COLD BRIDGING

This is an actual example of a project on which we were instructed to act. It is the worst case to date of cold bridging that we have encountered.

The issue was initially identified by us during a review of the subcontractor's drawings before the works began and thus could have easily been avoided.

EXTRACT OF SUB CONTRACTOR'S DETAIL

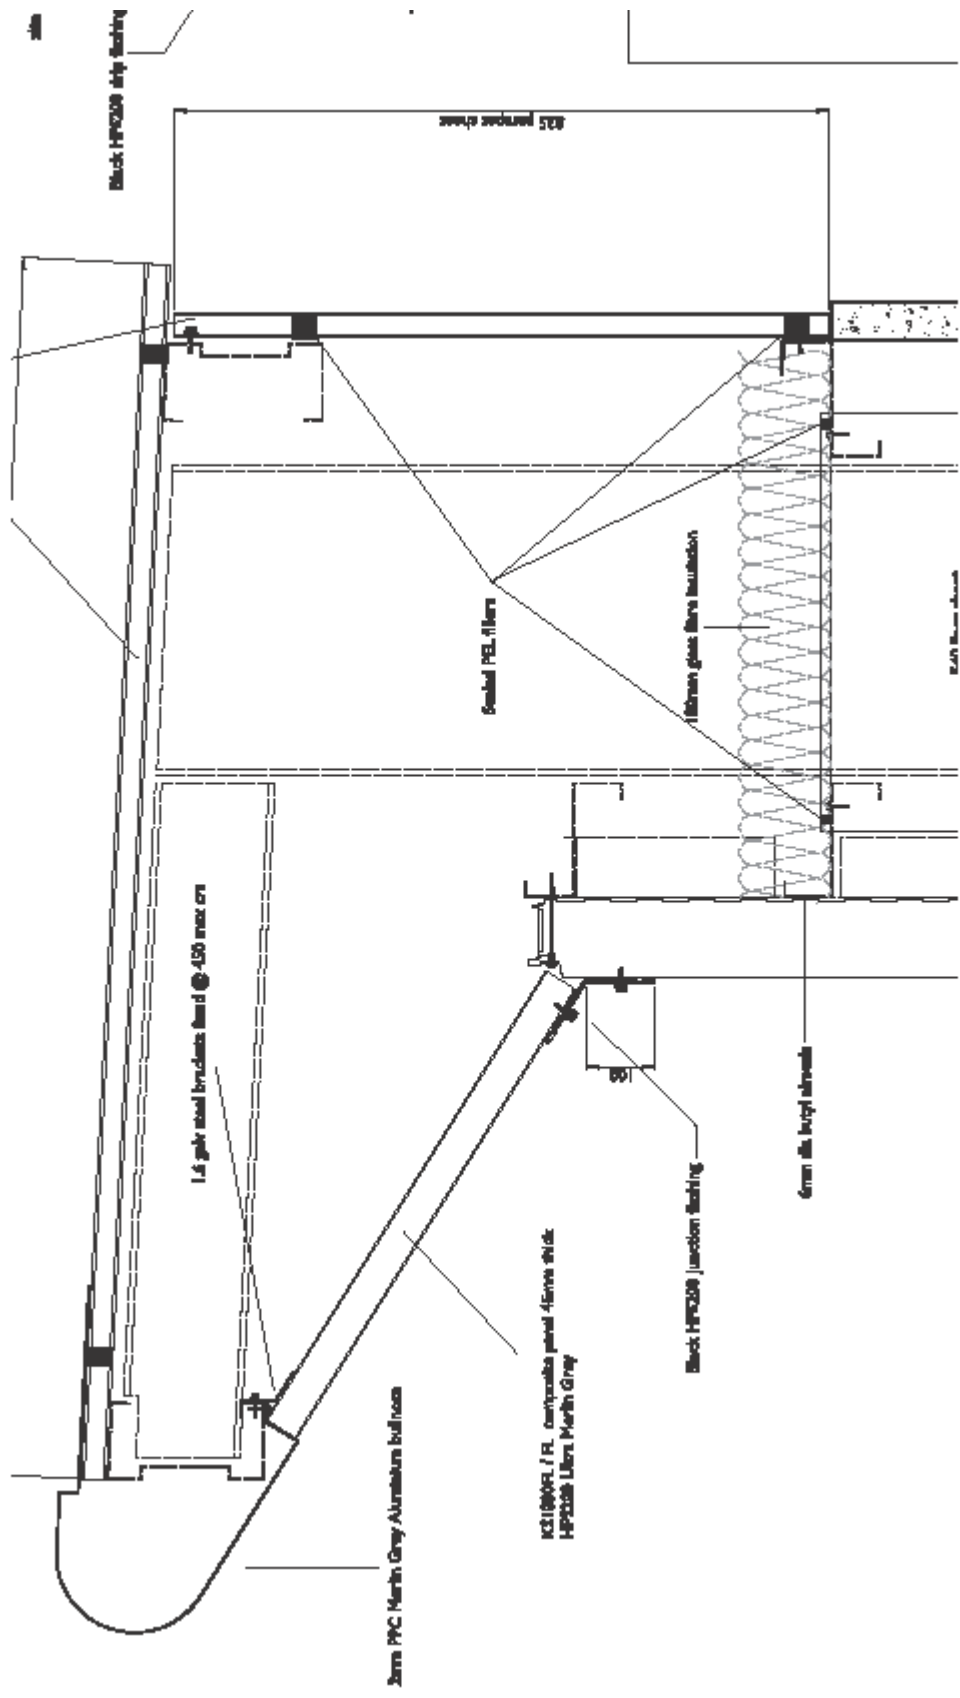
- a) The sub contractor has proposed closing off the parapet void by using a steel sheet laid across two proprietary cold rolled galvanised steel rails.

- b) The Main stanchion (457 UB) penetrates from the warm interior of the building into the un-insulated void of the parapet. This will form a serious cold bridge into the building.

- c) The parapet perimeter is not fully sealed. Although foam fillers have been indicated at various points, these are vented and not fully sealed; Thus they will not stop cold air penetrating the void. It should also be remembered that the various cold rolled steel members are usually fabricated as standard components and will contain holes that are unused and there will also be gaps at section joints. These holes and gaps will permit further free flow of air and those supporting the closure lining will allow condensation within the void to drip into the building and allow warm air to leak from within the building into the void.

- d) A further cold bridge occurs with the rail adjacent to the gutter. You will observe that the external vertical parapet sheet here is single skin and in direct contact with the rail. The underside face of the rail is exposed within the heated area of the building.

- e) Other than the sloping fascia, all other faces of the parapet are single skin.
- f) There are issues with non fragility of the top sheet and the sheet closing the cavity. However, this is outside the scope of this study.

Our concern was that condensation was inevitably going to occur here due to the cold bridges. Furthermore, continual condensation within the parapet void would cause the insulation quilt to become compressed and less thermally efficient, thus increasing the risk further.

An f factor calculation undertaken via ourselves shows a figure of 0.36. This building is at best Humidity Class 2, thus requiring a factor of 0.5. Hence this is a major issue.
